Subject: Duke Energy Corporation
Catawba Nuclear Station, Units 1 and 2
Docket Numbers 50-413 and 50-414
Proposed Technical Specifications and Bases
Amendment
Technical Specification and Bases 3.6.10
Annulus Ventilation System (AVS)
Technical Specification and Bases 3.6.16
Reactor Building
Technical Specification Bases 3.7.10
Control Room Area Ventilation System (CRAVS)
Technical Specification Bases 3.7.12
Auxiliary Building Filtered Ventilation Exhaust
System (ABFVES)
Technical Specification Bases 3.7.13
Fuel Handling Ventilation Exhaust System (FHVES)
Technical Specification and Bases 3.9.3
Containment Penetrations
Technical Specification 5.5.11
Ventilation Filter Testing Program (VFTP)
TAC Numbers MB7014 and MB7015

RESPONSE TO NRC REQUEST FOR ADDITIONAL INFORMATION

May 25, 2004 NRC RAIs on Filter Test Criteria

Telephone NRC RAIs on Chemistry

Figure 1 Post LOCA Ice Melt Rate vs. Time

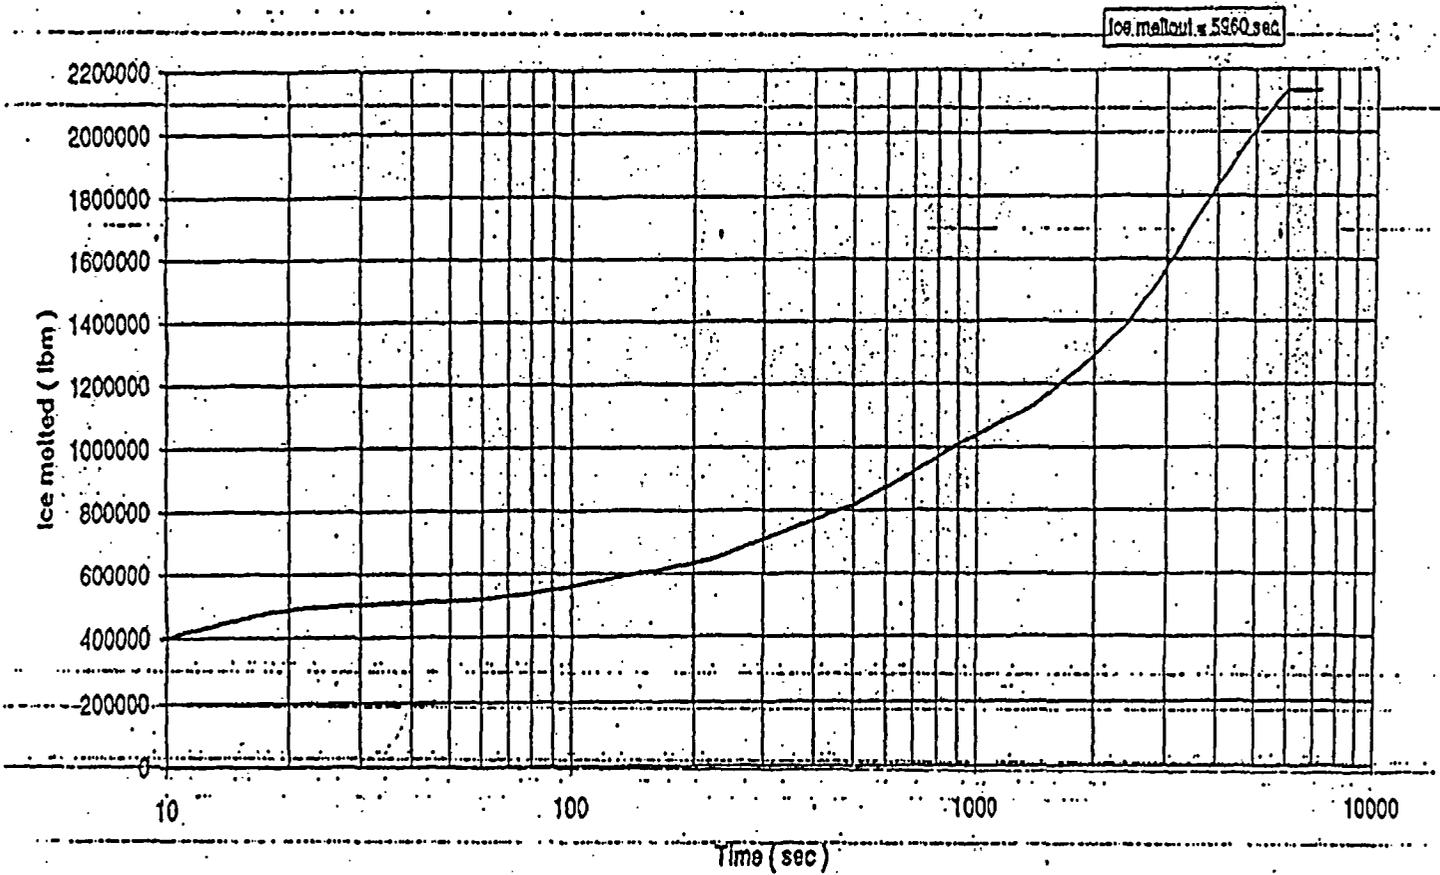
3. *Explain the difference between the curves in Figure 1 for normalized pH at 25 C and corrected pH at T_{sump}.*

Response: Two sets of values are calculated for post LOCA containment sump pH: one at a reference temperature of 25°C and the second at the upper bound limit for post LOCA temperature of the water in the sump. The values of containment sump pH are taken at reference temperature (25°C) in evaluations of the potential for chloride induced stress corrosion cracking of stainless steel components of the ECCS and CSS. Values of containment sump pH at 25°C also are used in the evaluation of other post accident phenomena. These include post LOCA production of hydrogen in the containment atmosphere and caustic corrosion of ECCS and CSS components.

On the other hand, sump pH values at actual solution temperatures are used in assessing the effect of sump water chemistry on the transport and release of iodine isotopes following a design basis LOCA. This conforms to the method of Beahm et al. (Ref. 7) which is used in calculations of time constants for CSS washout of iodine, and iodine partitioning from leakage of Engineered Safety Features (ESF) systems in the Auxiliary Building and RWST. This method predicts that the concentration of diatomic iodine [I₂] increases with increasing concentration of hydrogen ions [H⁺] or increases with decreasing pH. The concentration of hydrogen ions increases and pH decreases with increasing solution temperature. (The concentration of hydroxyl ions [OH⁻] also increases and pOH decreases with increasing solution temperature. However, the presence of pOH is not taken into account in the calculation of the production of I₂ per the method of Beahm et al.) Thus, as currently developed, the method of Beahm et al. predicts increased formation of I₂ with increasing solution temperature. For this reason, the pH of the containment sump is calculated at the post LOCA sump water temperature as well as at 25°C.
